Troy School District

**RFP #2425-09 - Addendum #1
BP#2B High School Athletics - Phase #2
January 21st, 2025**

Troy Schools District – RFP #2425-09 BP#2B High School Athletics Renovations - Phase #2

Addendum #1 Bidder Clarifications

DRAWING NO.
LD1.12

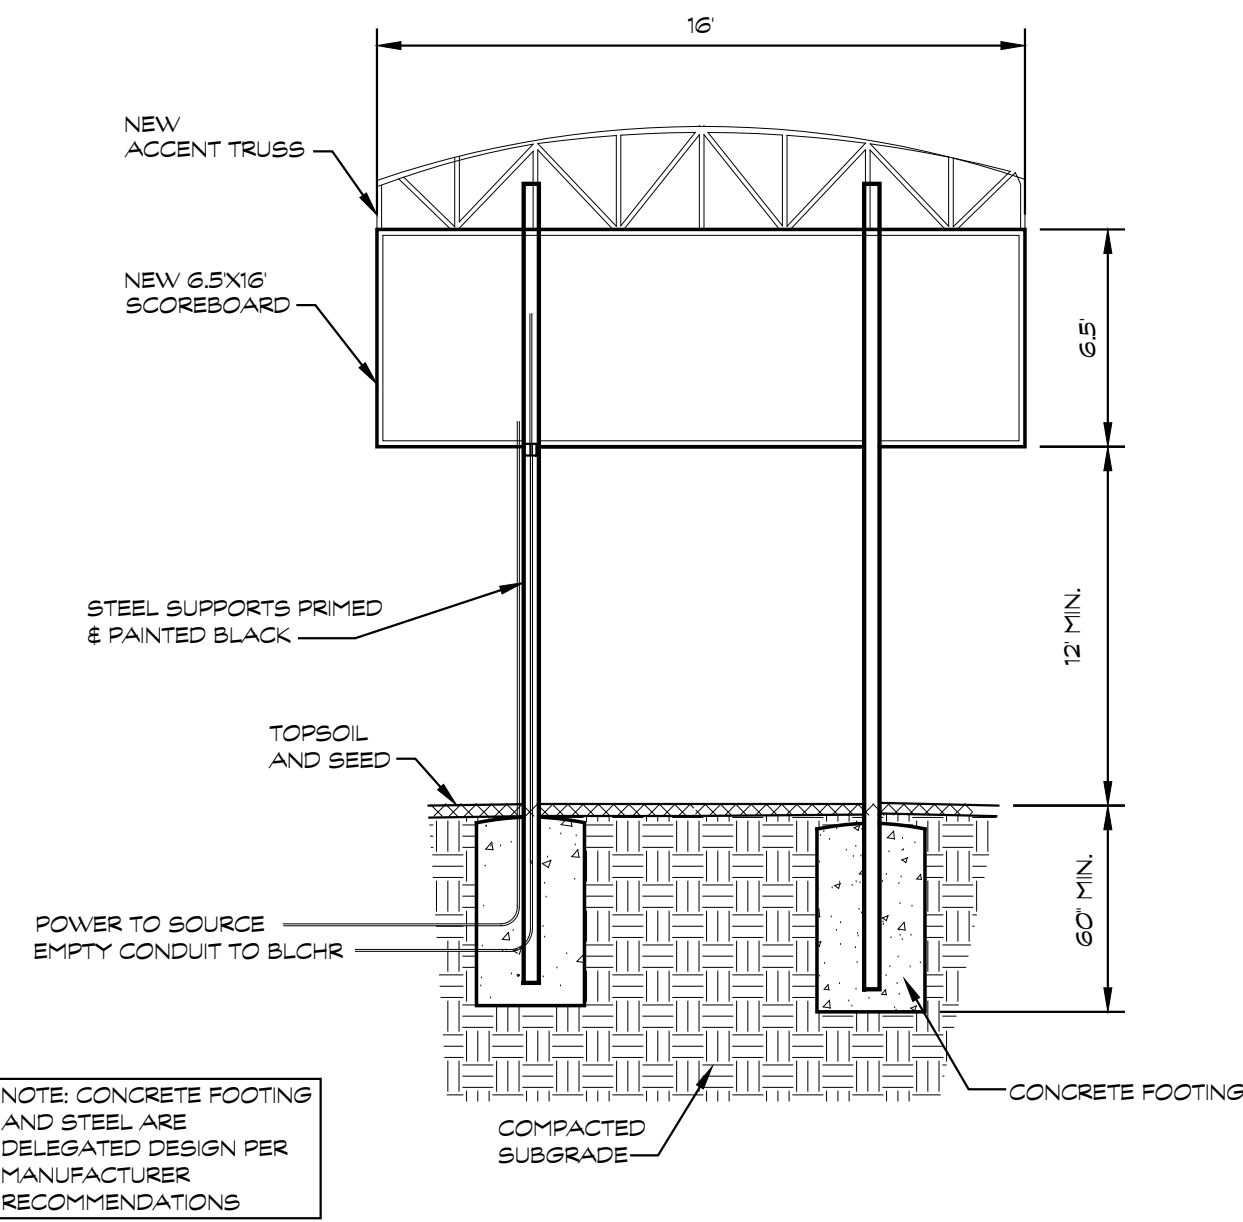
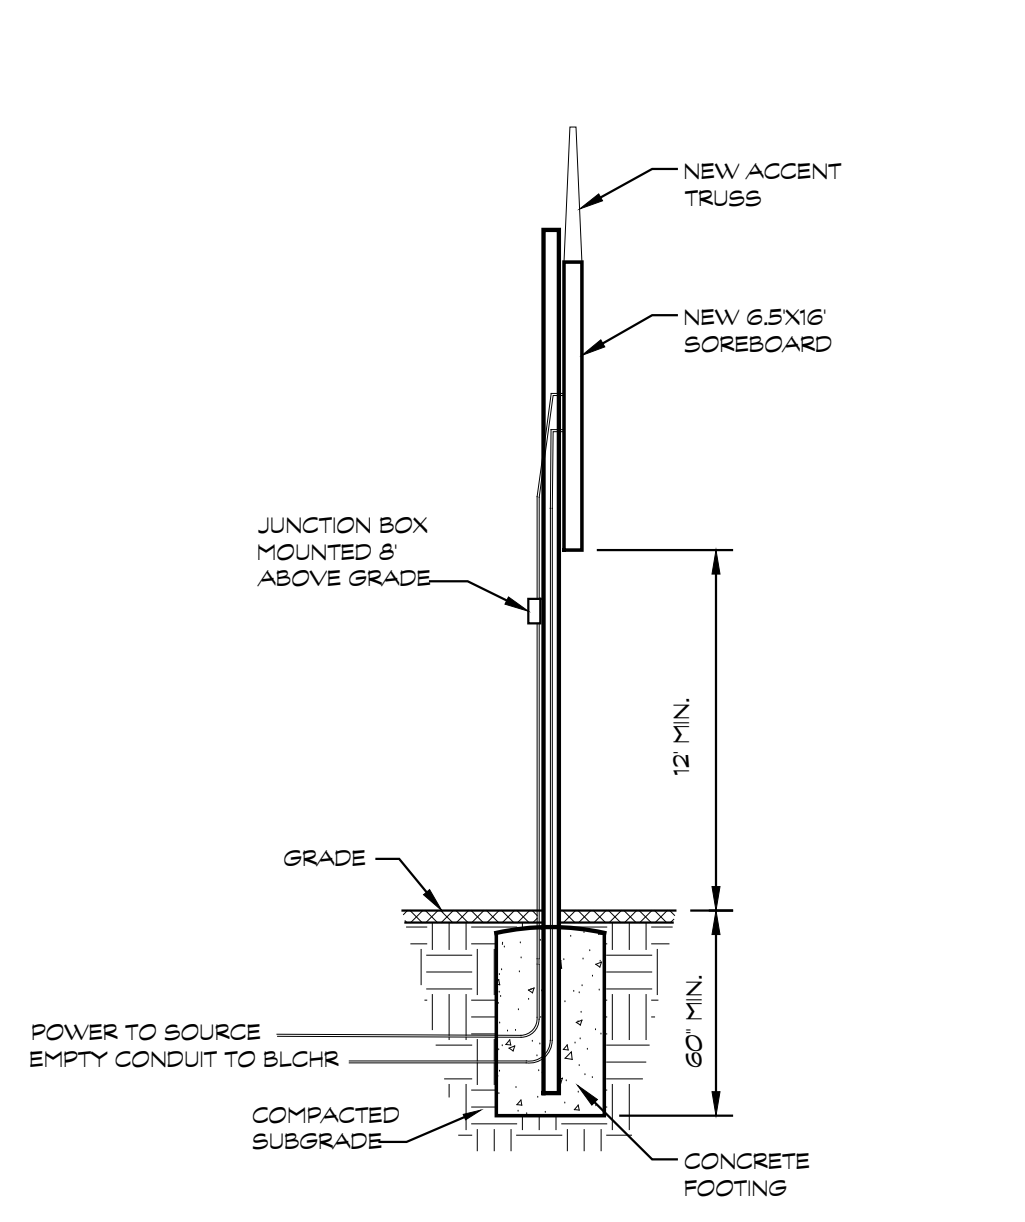
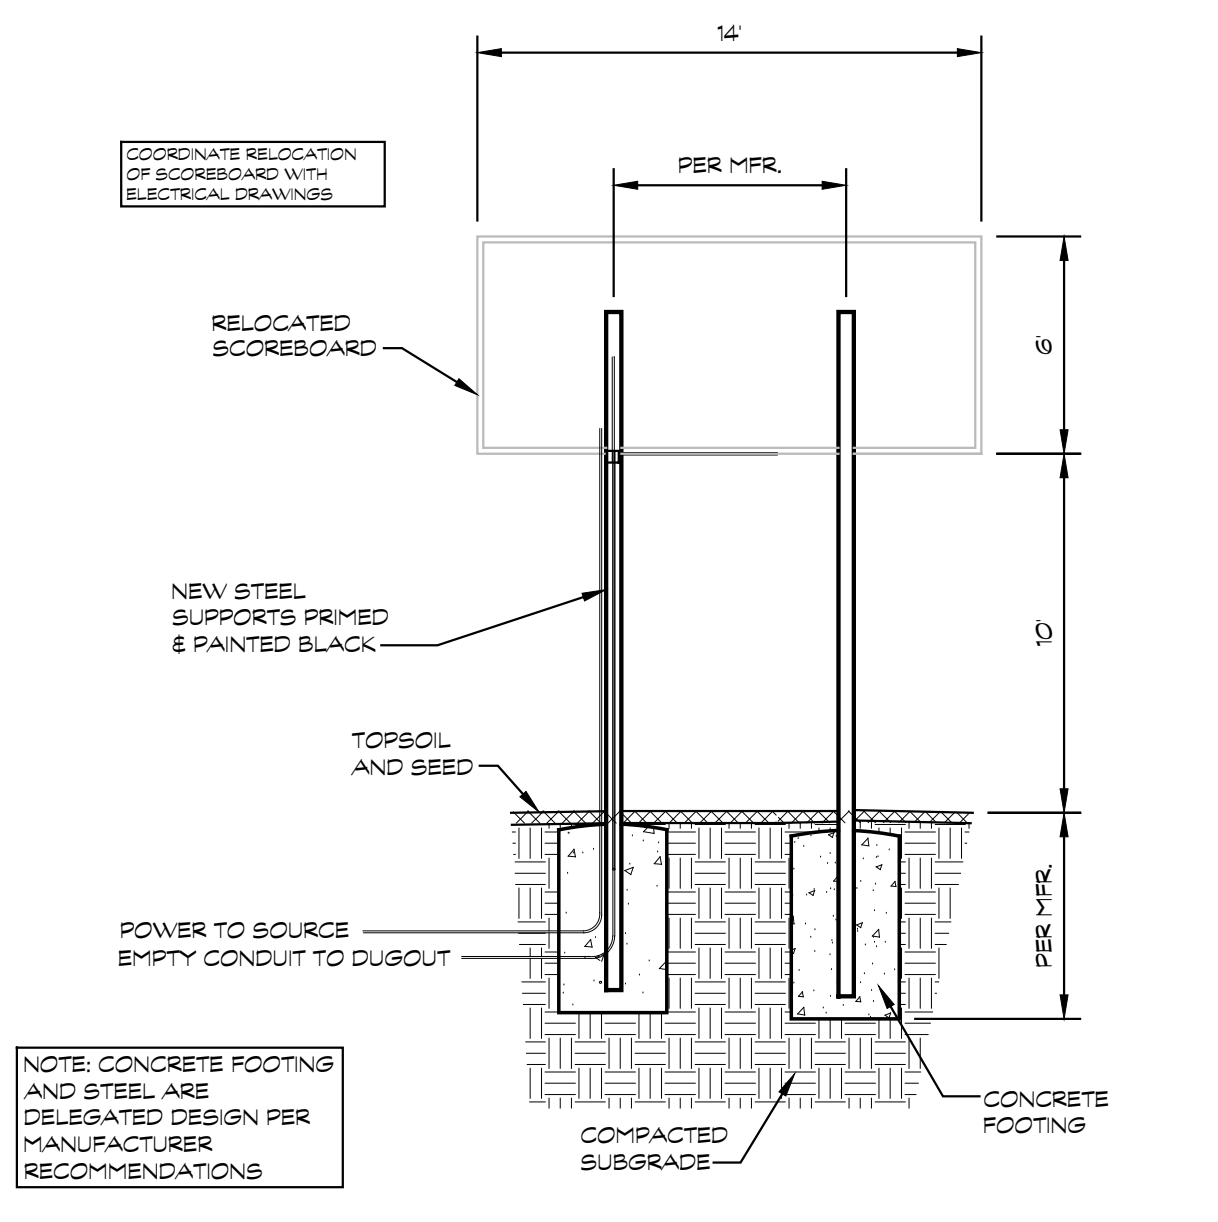
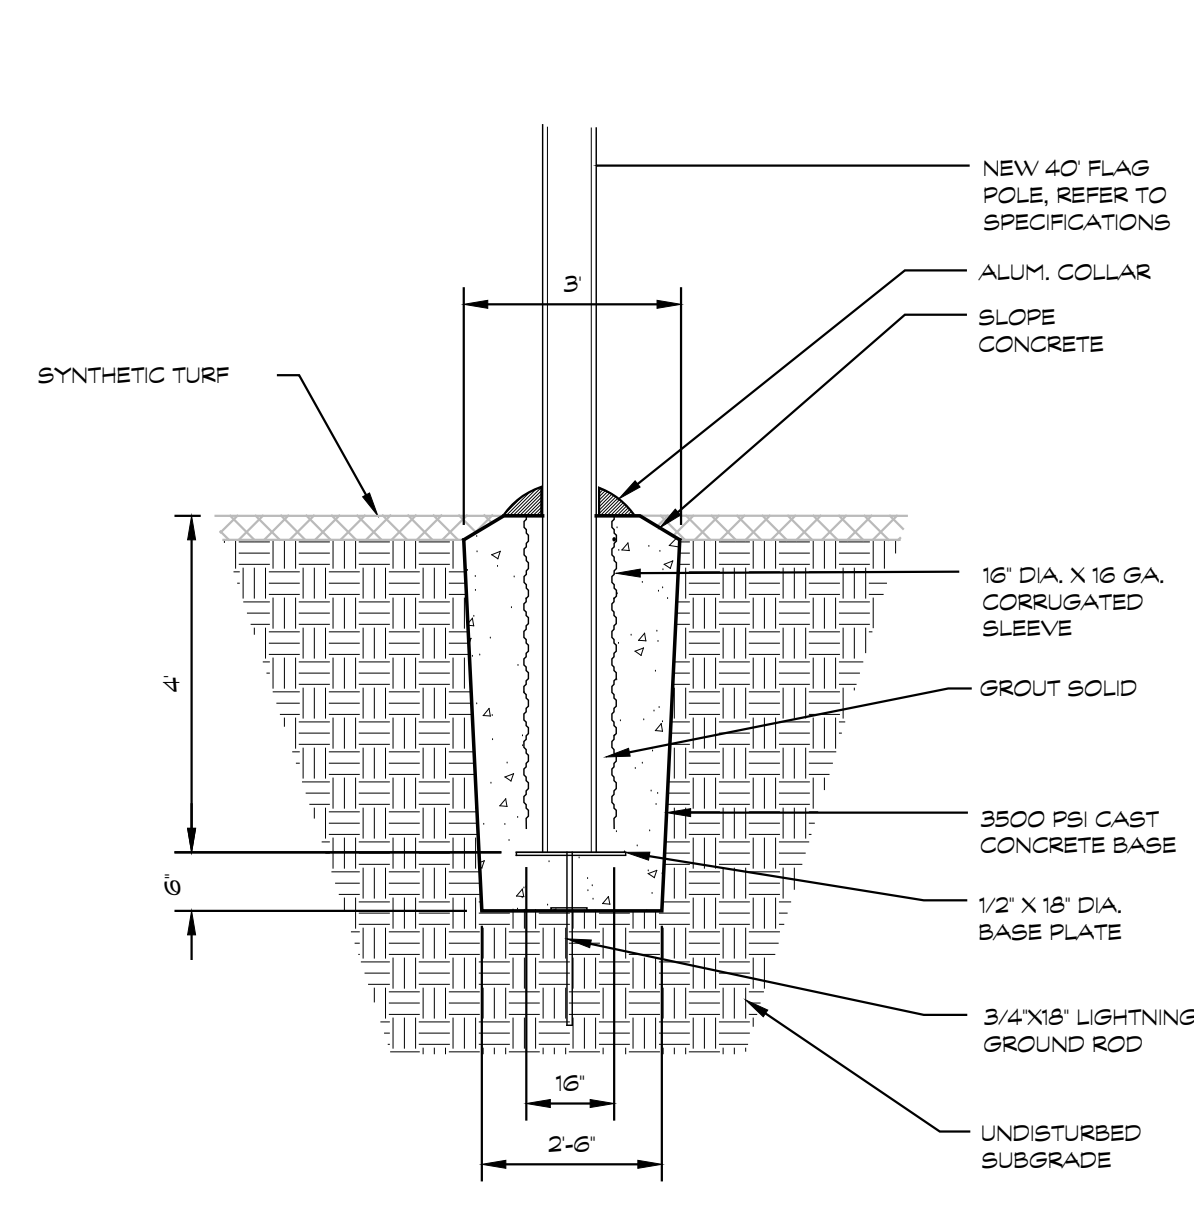
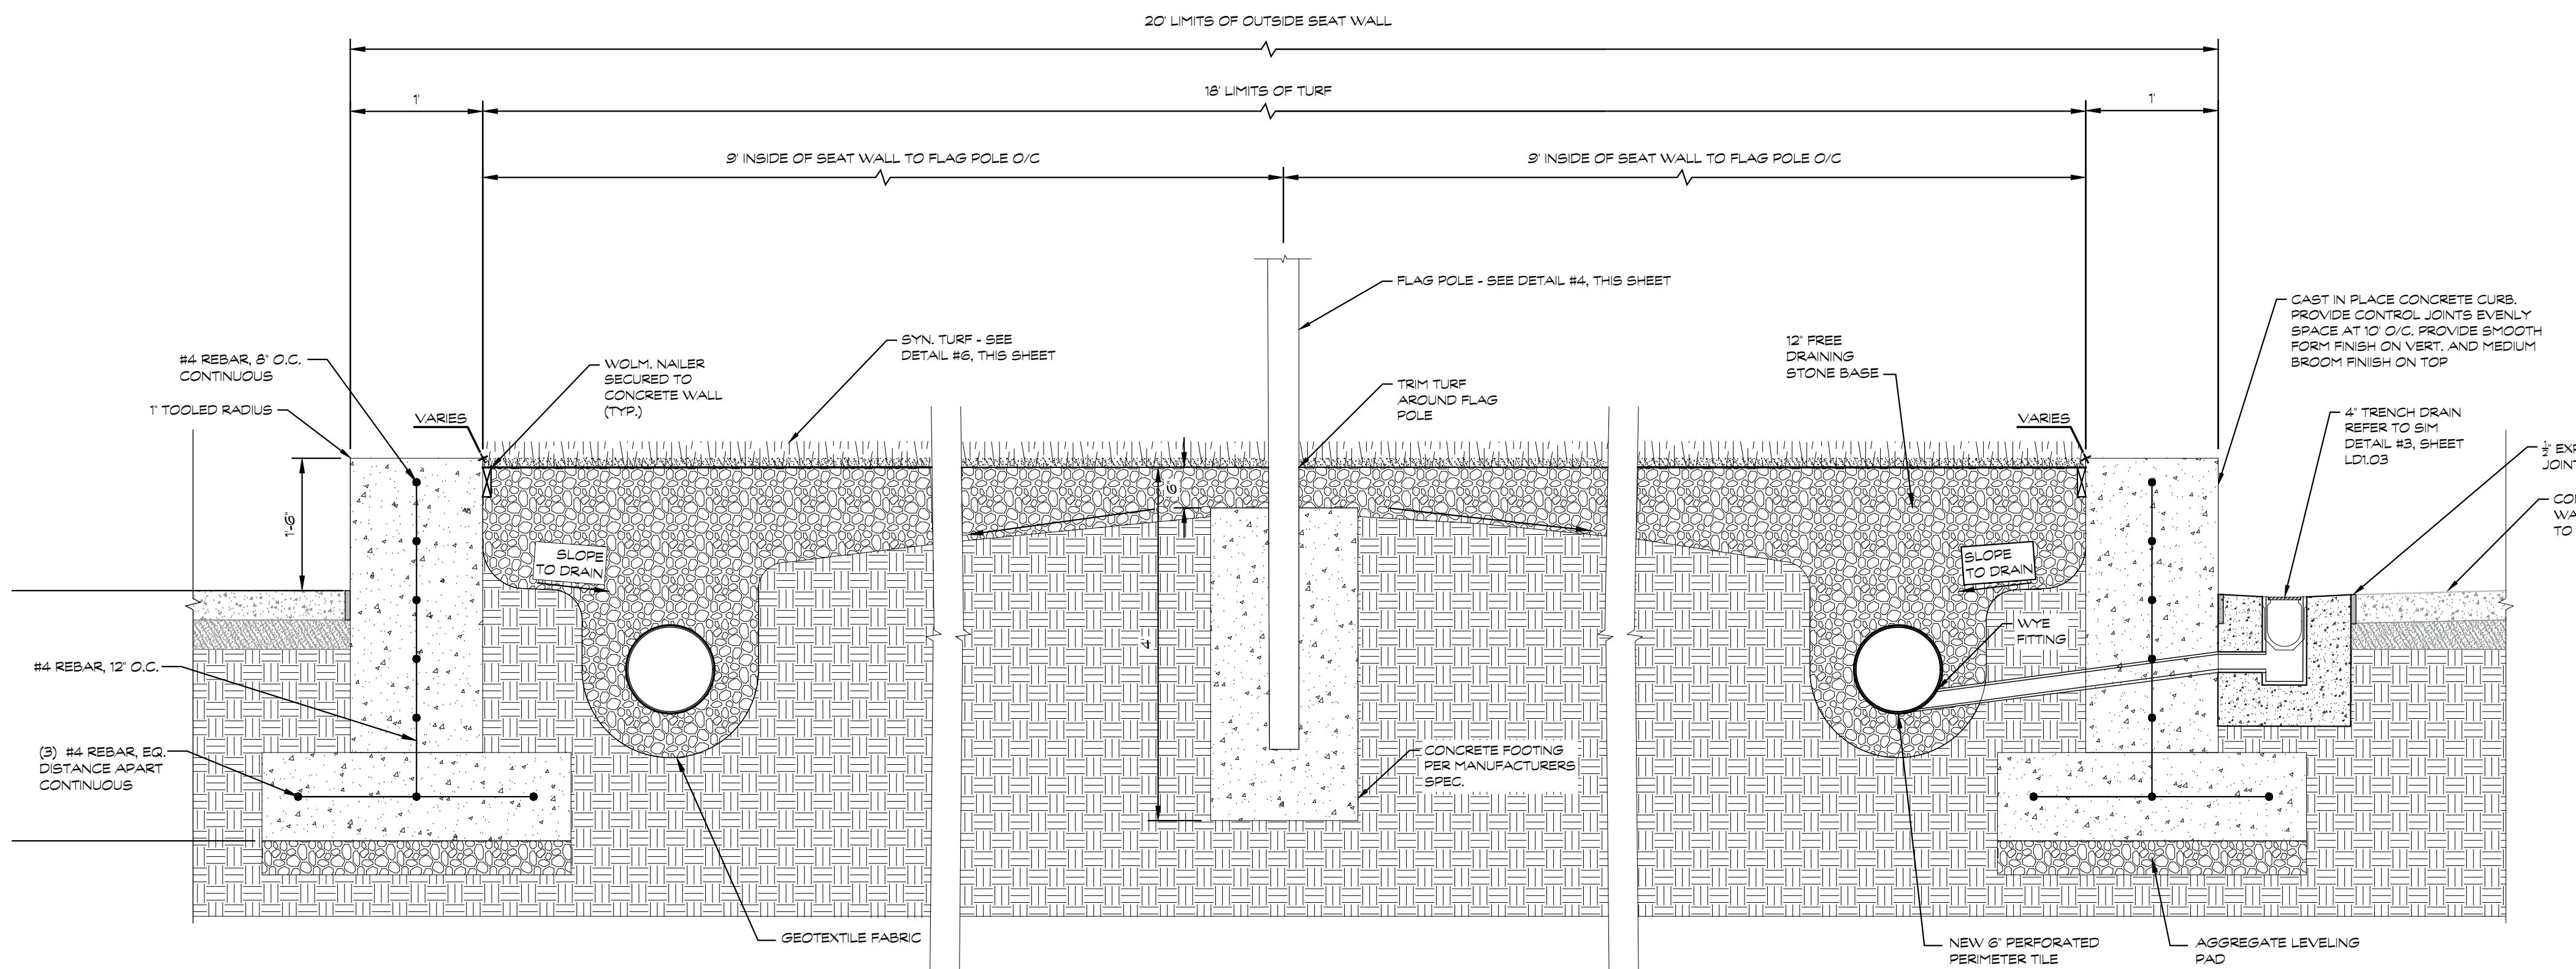
- LD-14 Refer to Drawing No. LD1.12 (reissued):
- A. Revised details; moved JV dugout details to different LD sheet as indicated.
 - B. Revised details; moved scoreboard details and flag pole details from different LD sheet onto sheet as indicated.
 - C. Added synthetic turf graphics detail for flag pole area as indicated.
 - D. Revised name of detail sheet to correspond with the details as indicated.
 - E. Revised flag pole focal point section in its entirety as indicated.
